Figure 7 Water Level Condition during Dike Failure

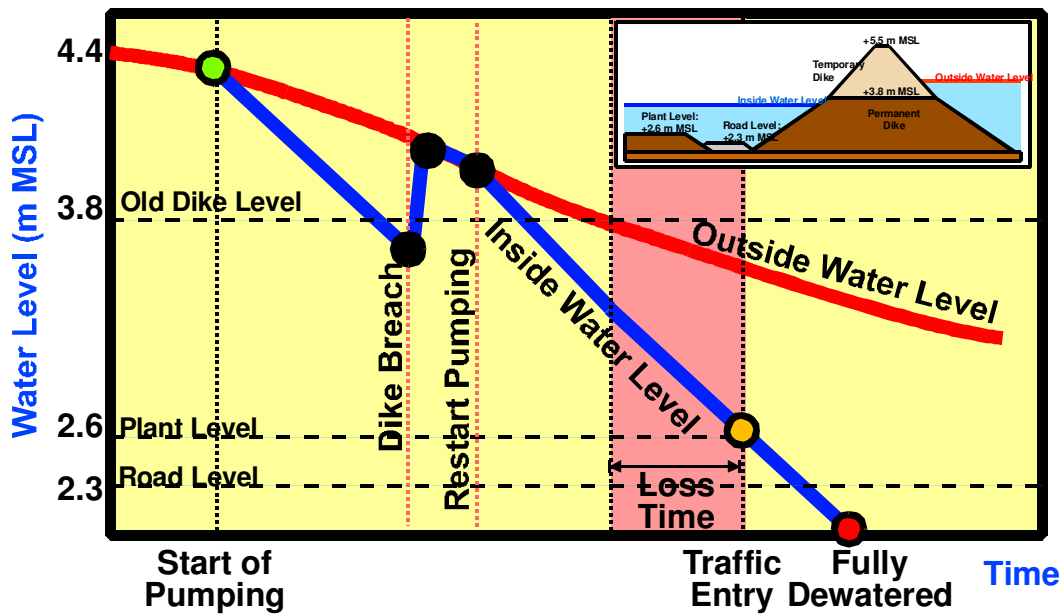
1. **Risk of dike breaching during pumping when outside water level is above +3.8 m MSL.** If pumping starts before the outside water level reaches +3.8m MSL, then there is a higher risk of dike breaching during pumping. The failure of dike will raise the inside water level to match the outside water level within a very short period with schematic shown in Figure 7. During repair of dike, the inside water level will equilibrate with the outside water level. Once the pumping has restarted, then the drawdown will continue. The consequence of the dike breaching with high outside water level is ***considered minor*** with minimum risk to safety, but there will be a loss in pumping time. Therefore, an early start in pumping is considered acceptable with some risk in time loss if the dike failed.

Figure 8 Expected Drawdown Time Curve

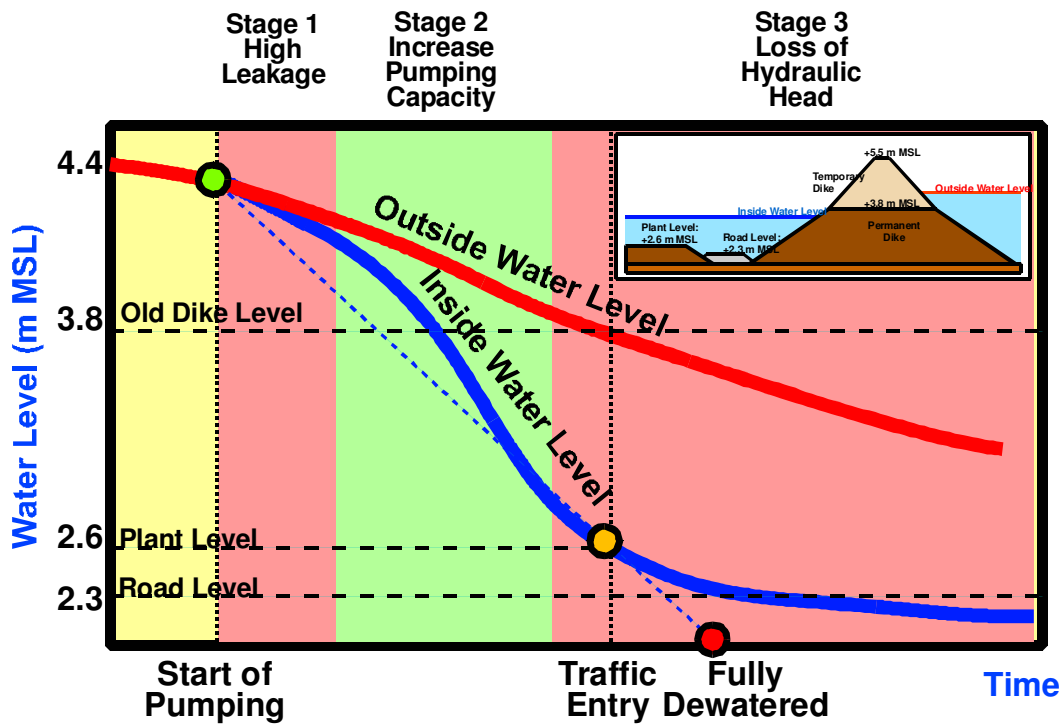
2. **Expected condition of drawdown.** A linear water drawdown within the estate will not be unlikely due to leakage through the dike at the top section (new fill) and low hydraulic head for full flow when the water reaches lower level. Figure 8 shows the possible stages of dewatering. During the initial pumping, large leakage through the new fill is expected, then the lowering of water will be low. To meet a particular target date, it may be necessary to increase the pumps half way through the dewatering process. For the low head condition in Stage 3, it will be necessary to distribute the mobile pumps over the boundaries for shortest the drainage paths which shall be discussed in detail soon.
